SERVICE BULLETIN

M1384

2015 HARLEY-DAVIDSON STREET FUEL TANK - SAFETY RECALL 0161

Figure 1. Fuel Tank

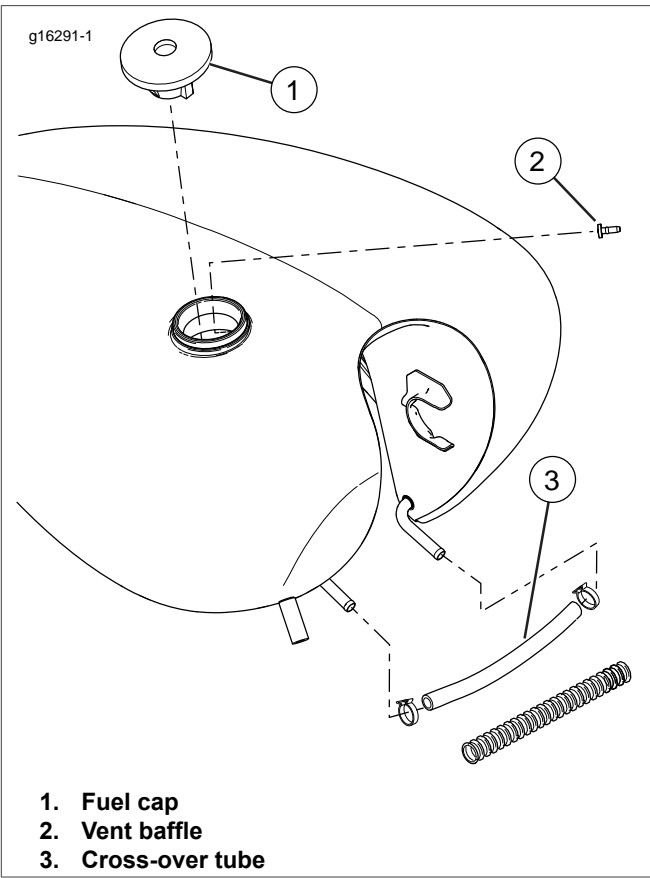
See Figure 1. New fuel tank will come with all components except:

- Vent baffle (2).
- Cross-over tube (3).
- Fuel cap (1).

When removing or installing vent baffle, cover fuel tank inlet to prevent vent baffle from falling into fuel tank.

2. Transfer vent baffle (2) from old tank to new tank.
3. Install new fuel tank. See service manual.
4. Install cross-over tube (3) and **new** clamps.
5. Fill fuel tank with fuel.
6. Install fuel cap (1) from old fuel tank to new fuel tank.

The fuel cap, once installed, must sit undisturbed for a minimum of 12 hours. This allows the cap seal to take the shape of the new tank.

7. After the fuel cap has been installed on the new tank for at least 12 hours, test for leakage between fuel cap and tank. If fuel leak is present, contact Technical Service.
